WILBUR ADDITION
WICHITA, SEDGWICK COUNTY, KANSAS

RE: SUB 2000-104 -- One-Step Final Plat of WILBUR ADDITION

RE: SUB 2000-104 -- One-Step Final Plat of WILBUR ADDITION

CASE NUMBER: SUB 2000-104 -- WILBUR ADDITION

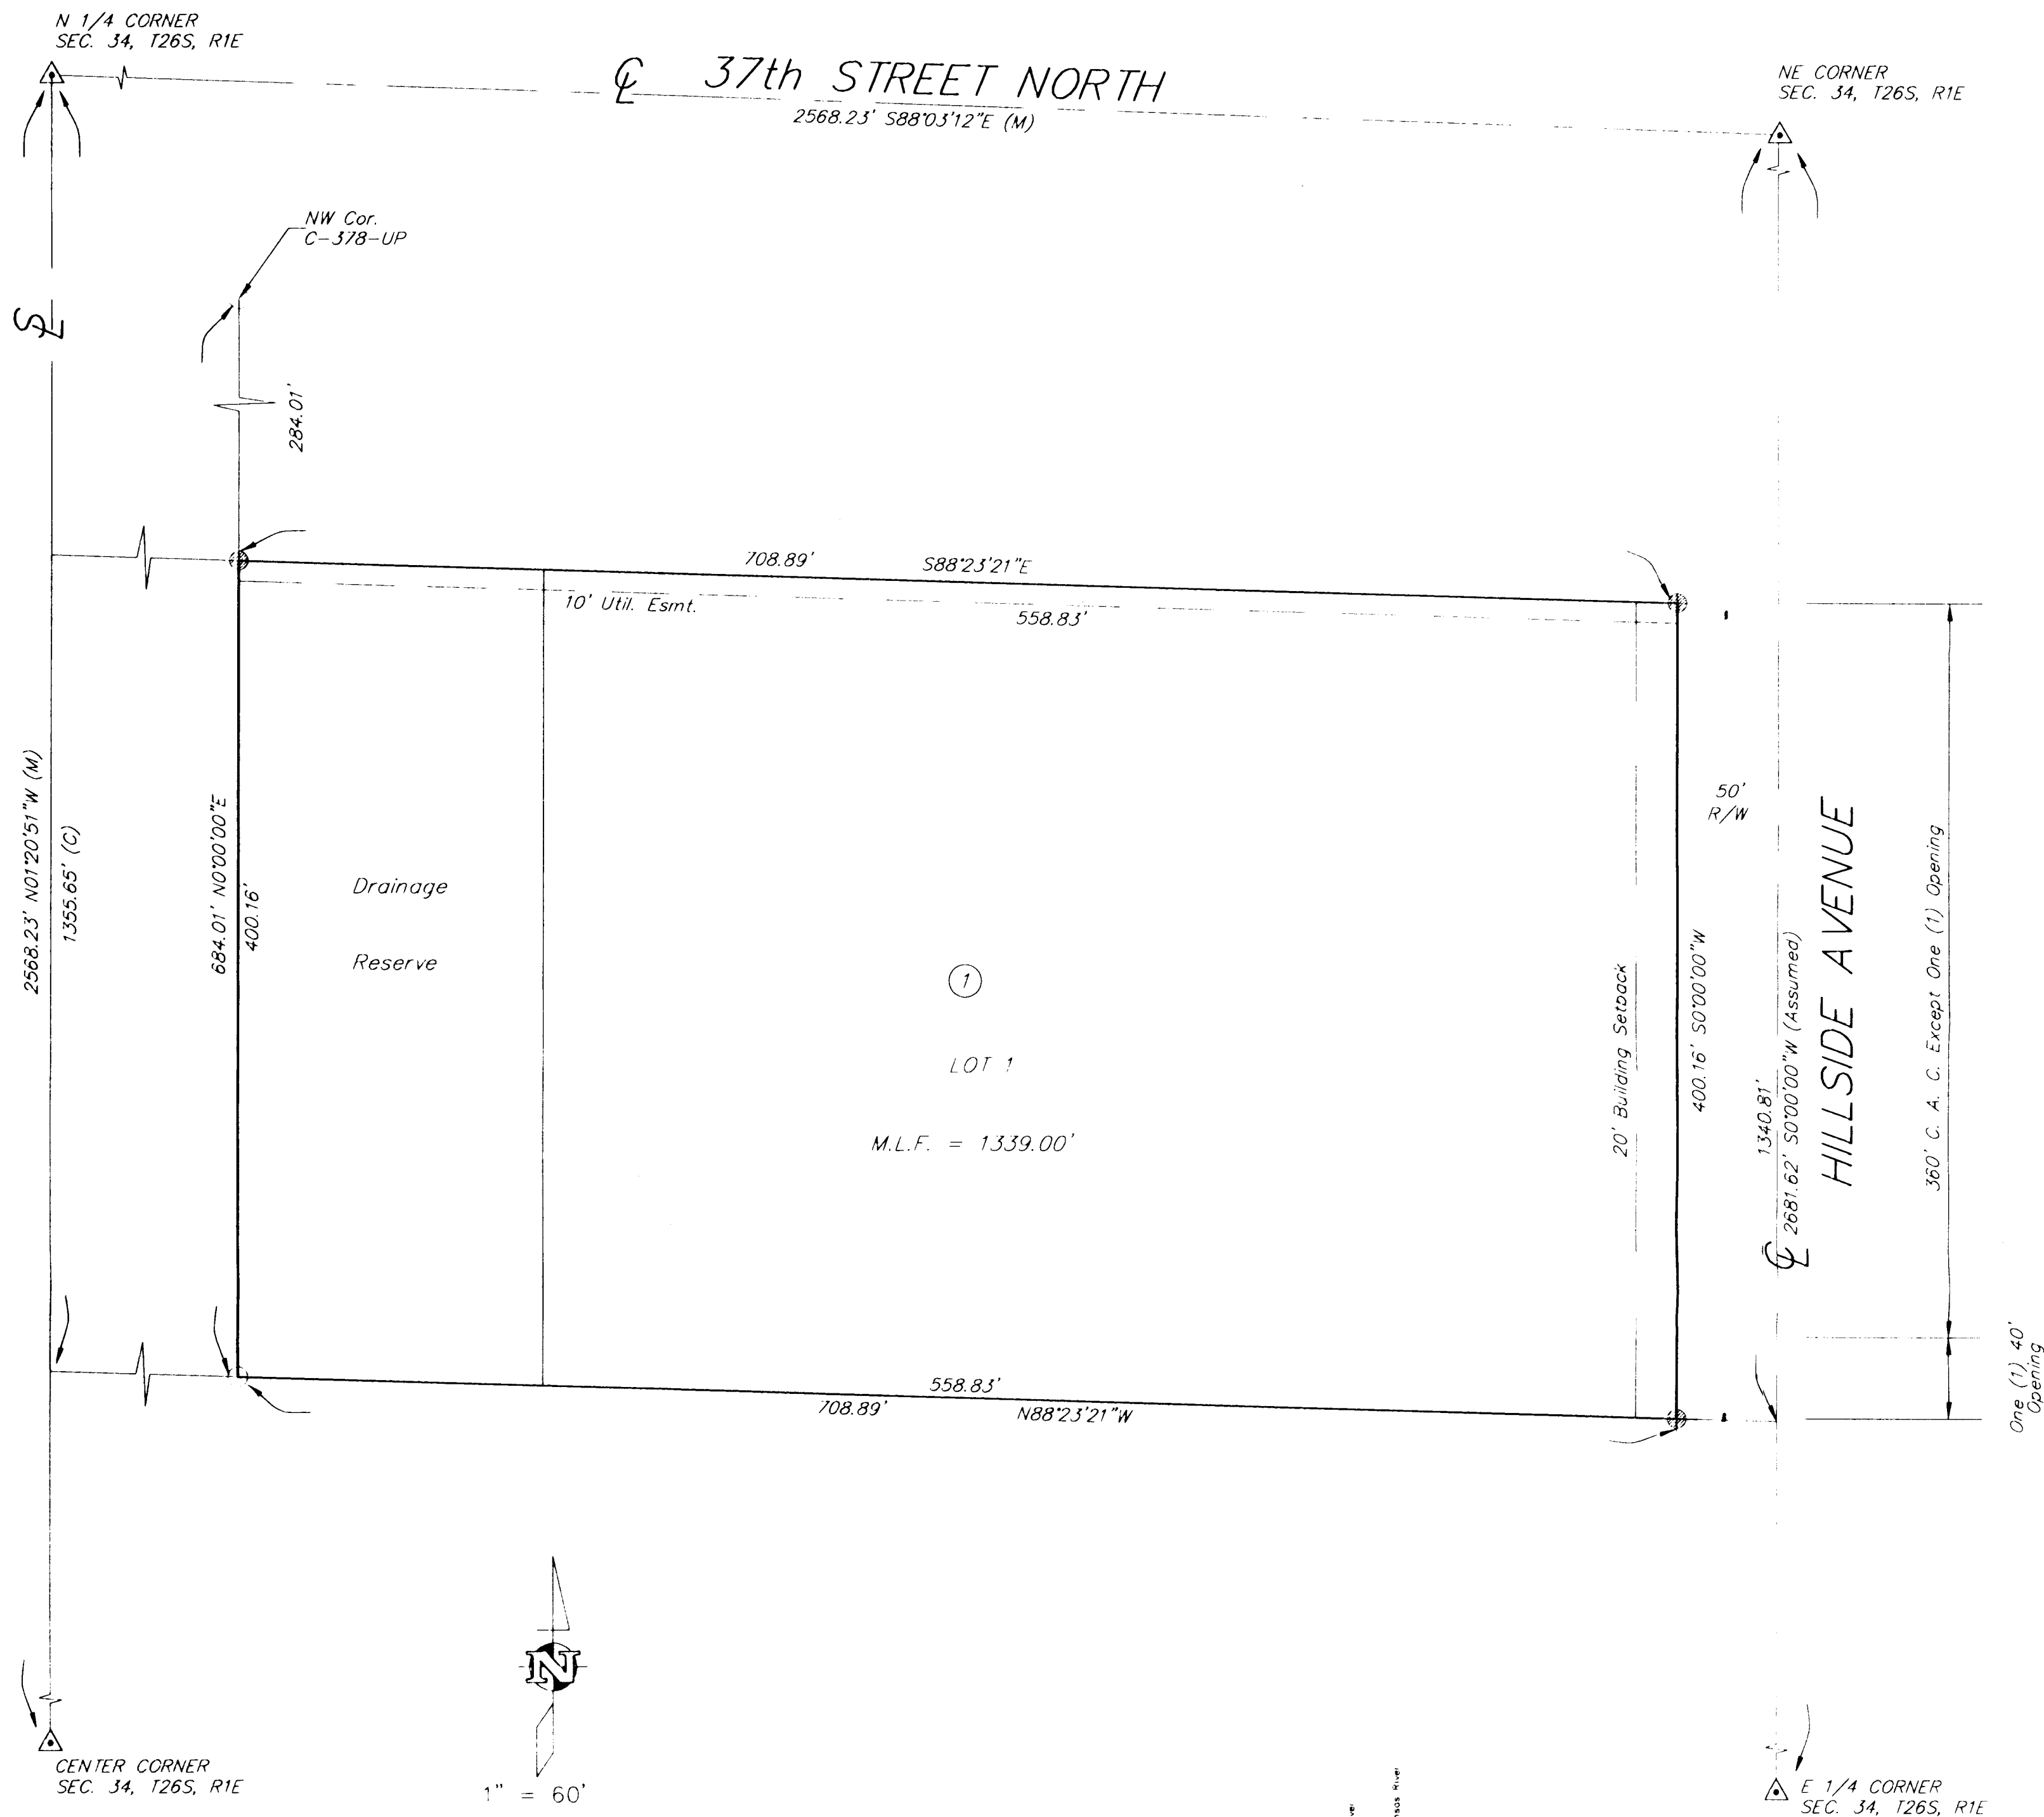
- A. Since neither municipal water nor sanitary sewer is available to serve this property, the applicant shall contact the Environmental Health Division of the Health Department to find out what tests may be necessary and what standards are to be met for approval of on-site sewerage facilities and water wells. A memorandum shall be obtained specifying approval. *A restrictive covenant is required that prohibits non-domestic uses on the site until public sewer is available.*

- B. City Engineering needs to comment on the need for any guarantees or easements. *A petition is required for future extension of sanitary sewer.*
- C. If improvements are guaranteed by petition, a notarized certificate listing the petitions shall be submitted to the Planning department for recording.

- D. City Engineering needs to comment on the status of the applicant's drainage plan. *An off-site drainage agreement and a drainage reserve is required.*

- G. **Traffic Engineering** needs to comment on the access controls. The plat proposes two access openings along Hillside. The Subdivision regulations encourage shared access for commercial/industrial lots along arterials. **Traffic Engineering has approved the access controls with one opening to be located along the south line of the property.**

- H. If platted, the building setback may be a minimum of 20 feet to conform with the LI District zoning standards.
- I. The signature line for the County Clerk needs to be revised to reference "Don Brace".

- J. The signature line for the MAPC Chairman needs to be revised to reference "Christopher S. Carraher".
- K. The plat's text shall include language that a drainage plan has been developed for the plat and that all drainage easements, rights-of-way, or reserves shall remain at established grades or as modified with the approval of the applicable City or County Engineer, and unobstructed to allow for the conveyance of stormwater.

- R. Recording of the plat within thirty (30) days after approval by the City Council and/or County Commission.
- S. The representatives from the utility companies should be prepared to comment on the need for any additional utility easements to be platted on this property. *KGE has requested additional easements.*
- T. The applicant is reminded that a disk shall be submitted with the final plat tracing to the Planning Department detailing this plat in digital format in AutoCAD. This will be used by the City and County GIS Department.
